Re: FortisBC Inc. ("FortisBC") Naramata Substation Project

Please find enclosed for filing twenty copies of FortisBC's response to Information Request No. 2 from Naramations Against Fortis Substation ("NAFS") and Mr. David Andrew. FortisBC considers that some of the questions posed are more appropriately dealt with in hearing and, pursuant to the Commission's letter of June 22, 2007 (Exhibit A-8) will be prepared to respond at that time.

7 **2.33.0 Reference: Exhibit B-5, NAFS A1.56.4 and p.59, photo with line of sight**
8 **elevation diagram**

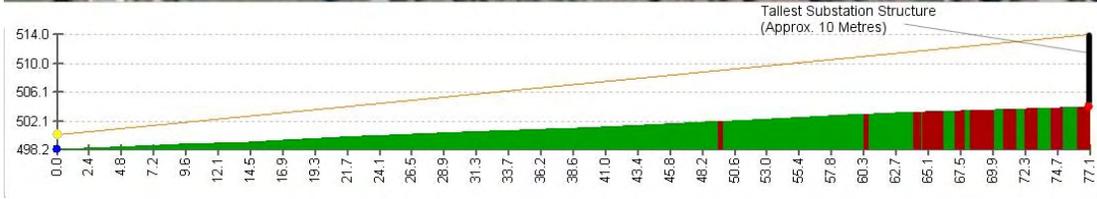
9 **Q2.33.1 Please confirm that the line of sight diagram on p.59 shows that the entire**
10 **substation, from the base upward, would be visible by a direct line of sight from**
11 **the point of origin on Arawana Road.**

12 A2.33.1 The entire substation would not be visible.

DESIGNED BY:	L. SANJILDO	SEP/06
CHECKED BY:		
APPROVALS:		
DIVISION:	OKANAGAN	
DEPARTMENT:	TRANSMISSION-DISTRIBUTION	
LOCATION:	PROPOSED FIREHALL SITE	
TITLE:	EXISTING STATION CROSS-SECTIONS 1 OF SHEET 1	
SCALE:	None	SCALE FACTOR: 1
DRAWING NUMBER:	3-330-XXXX	REVISION:
		0

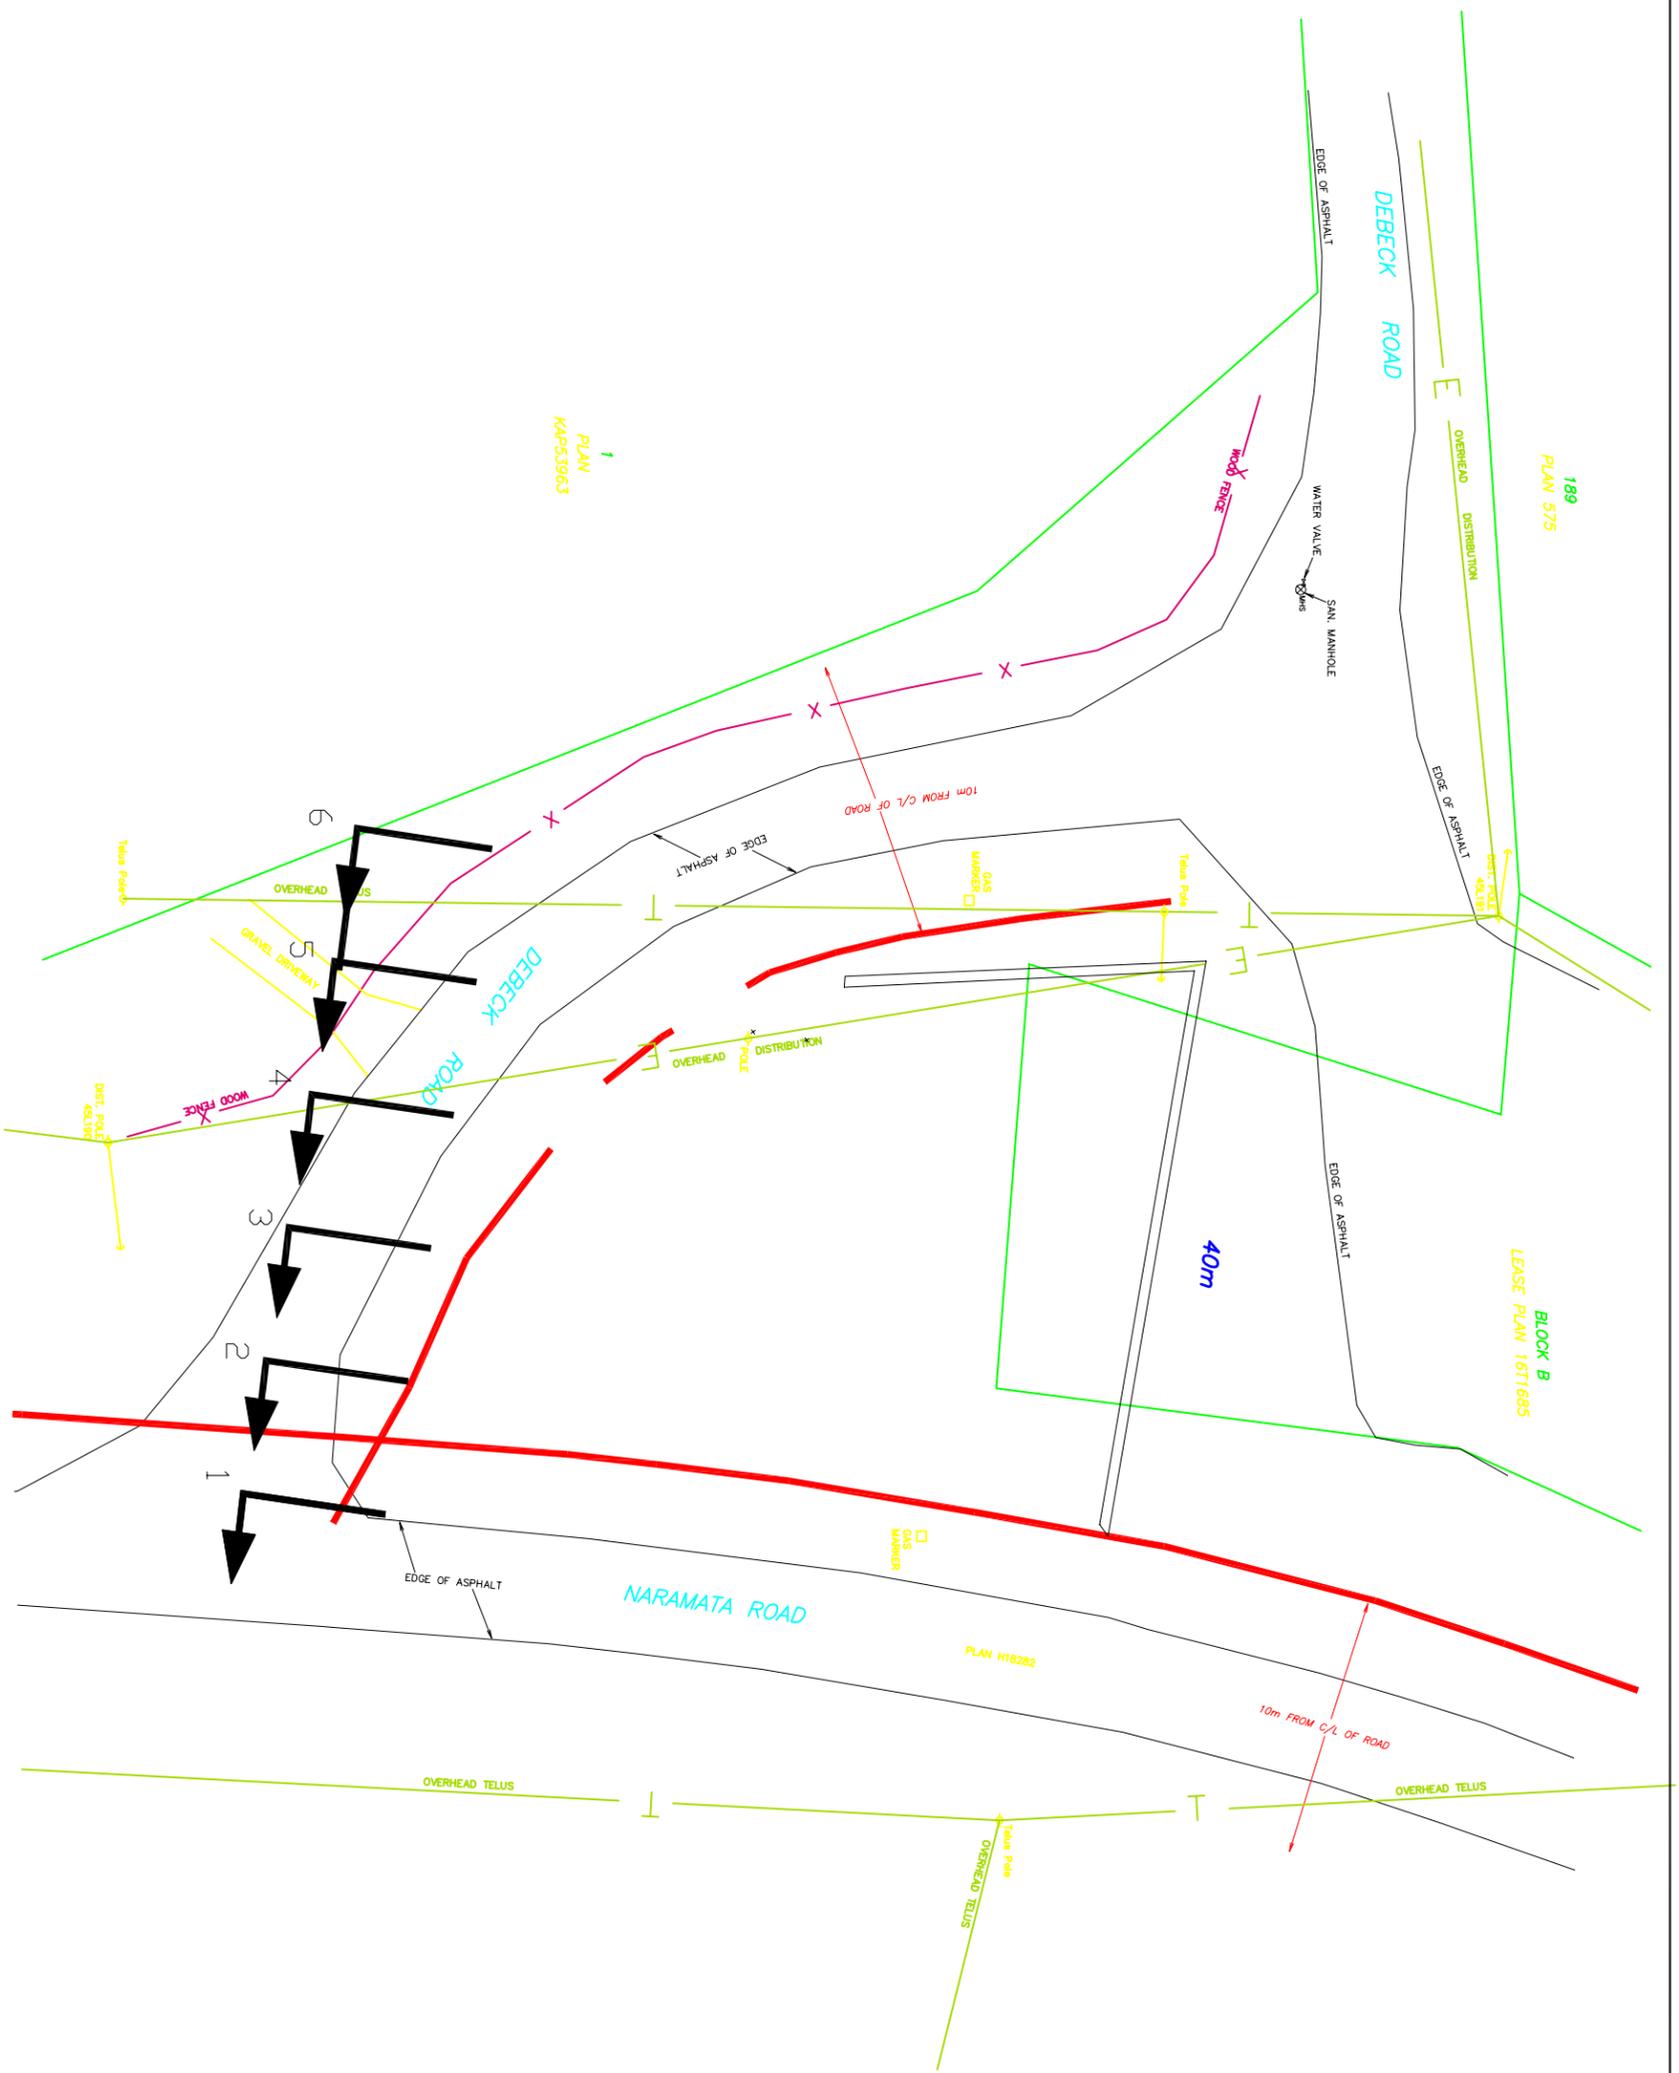
- 14 A2.51.1 Please refer to the response to BCUC IR1 Q4.1.3.
15
- 16 **2.52.0 Reference: Exhibit B-5, Andrew Appendix A1.3**
- 17 **Q2.52.1 Is the title (“Existing Station Cross-Sections”) incorrect? Should the title be Fire
18 Hall Cross-Sections?**

- 19 A2.52.1 Yes, the title should be Fire Hall Cross-Sections.
20
- 21 **Q2.52.2 Please provide the plan showing the sections (1 to 6).**
- 22 A2.52.2 Please see Appendix 2.52.2 attached. The plan shown in the appendix is marked with
23 arrows numbered 1 through 6 which denotes the approximate location of the sections
24 shown Andrew IR1 A1.3.
25
